22/14 Oatland Farm Subdivision

Oatland Farm Site Plan

Site Plan Review #8-95037

Oatland Farm Site Plan #8-95037

OLD DRIVE LOT (SETTING)

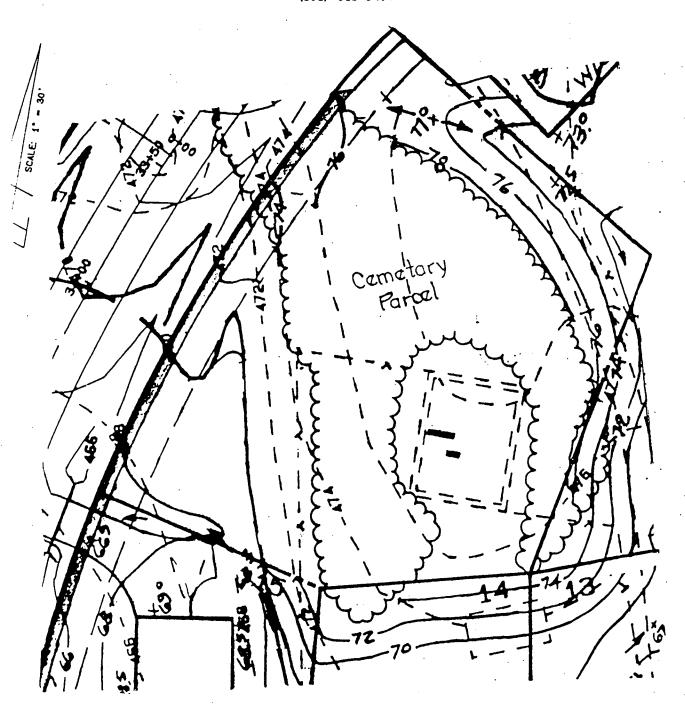
It is the intent to use portions of the current driveway as part of the path system through the parkland. The part adjacent to the pond will be a pedestrian trail owned and maintained by the Parks Department that will wind close to the historic house (although not on the legal lot for the house) and that will provide a high degree of visibility for the historic property (see attached page 4).

Condition #2 - The applicant has submitted a plan for landspacing and fencing the cemetery lot (see attached pages 5 and 6). The fencing will match that current existing near the historic house - three board wooden fencing, painted white. There will be a historic plaque and the applicant will research and propose detailed language for the plaque at the time they apply for a Historic Area Work Permit (HAWP). The applicant understands that a HAWP is needs for the fencing, the plaque, and the new path near the cemetery.

Condition #3 - The applicant is proposing a mixed deciduous and evergreen buffer along the backyards of all new lots adjacent to the historic house. Staff has encouraged the applicant to develop a naturalistic-looking buffer which will provide adequate screening to separate the historic property from the new backyards.

Staff feels that the HPC should revise their previous condition and accept the use of a portion of the original driveway as part of the trail/path system through the parkland.

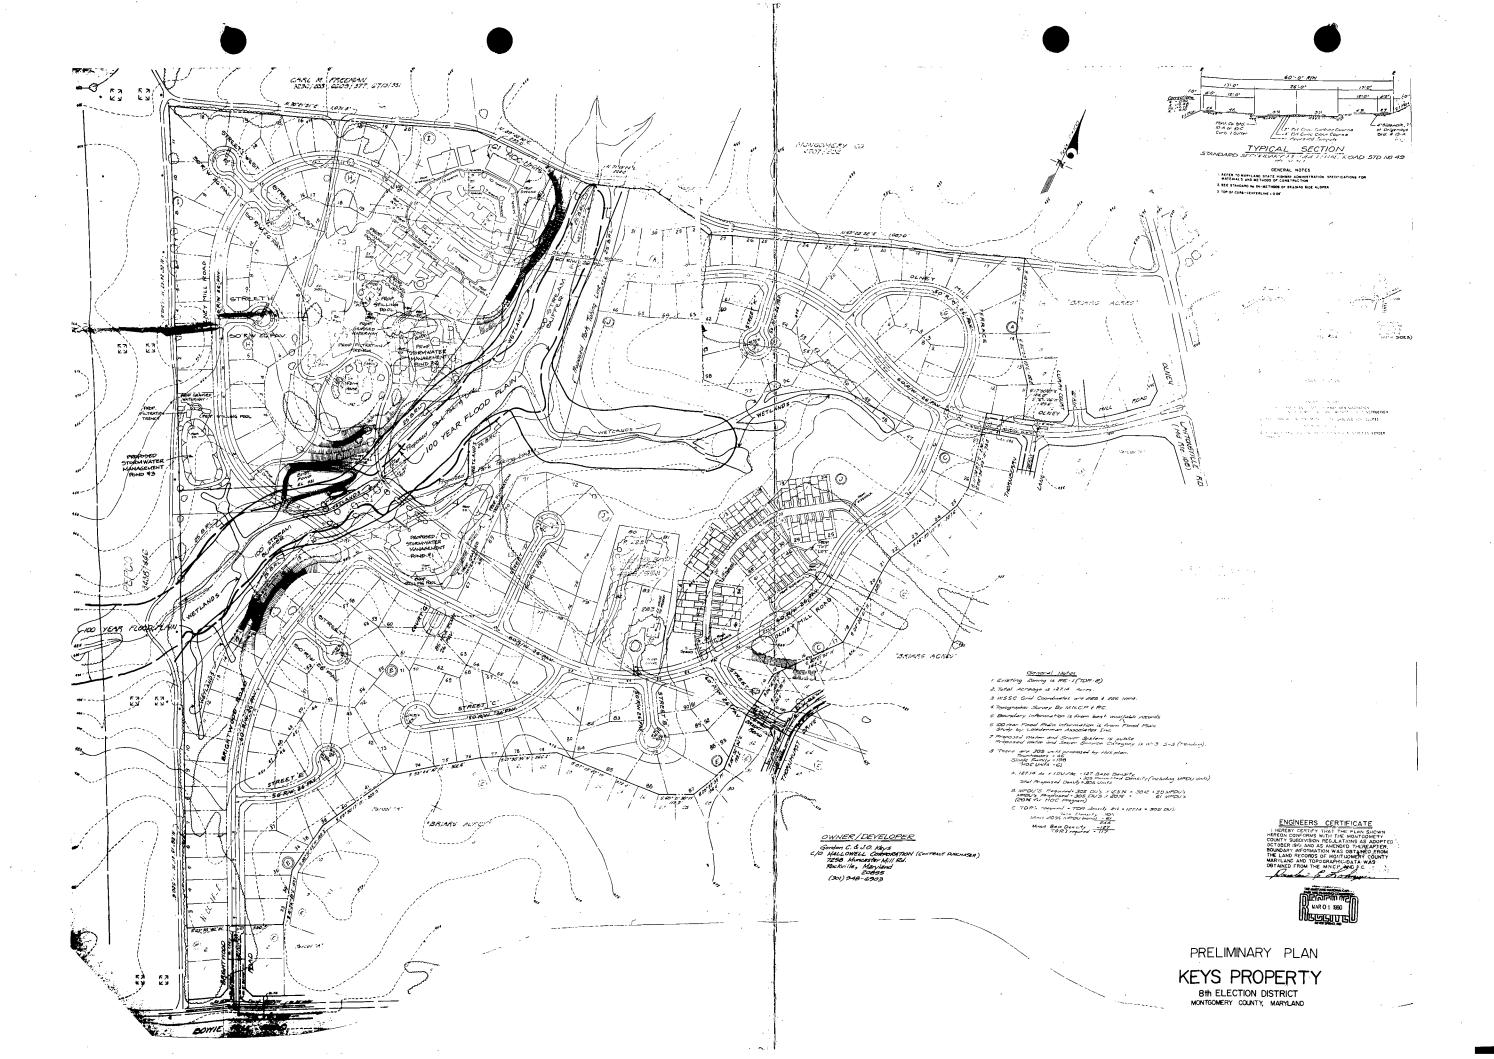
Also, it should be noted as a correction that - after a recent site visit - staff determined that the road shown to the west of the cemetery on the plan submitted is actually located to the east of the cemetery. That is, the farm road shown through Lot #14 is existing and should be shown to continue north.

A second significant issue is that the front entry drive past the stone mill house and the pond should be retained for vehicular access. This access will serve to enhance the environmental setting and will maintain the historic approach to the house. If a second point of vehicular access is proposed through the 50' frontage between Lots #15 and #17, then this information should be indicated on the plan.

Finally, buffering the environmental setting on Lot #16 from the new construction will be very important. To this end, additional planting of trees should be provided for all lots which are contiguous with the environmental setting.

- o The front entry drive to Oatland Farm should be retained for vehicular and pedestrian access. The proposed bituminous road should be widened to provide a driveway to the house as well as a path system for the park area.
- o The environmental setting for the cemetery should be enhanced with adequate landscaping, fencing and a historic marker. Create and landscape a complementary entrance path for the cemetery. A detailed plan for this area should be provided at the time the Site Plan is submitted.
- o Provide additional trees at the rear of all lots which are adjacent to the historic house so as to provide a buffer between the new construction and the environmental setting.
- o If another vehicular access to the historic house is proposed (especially at the 50' frontage on a public street), indicate this new access on the plan.
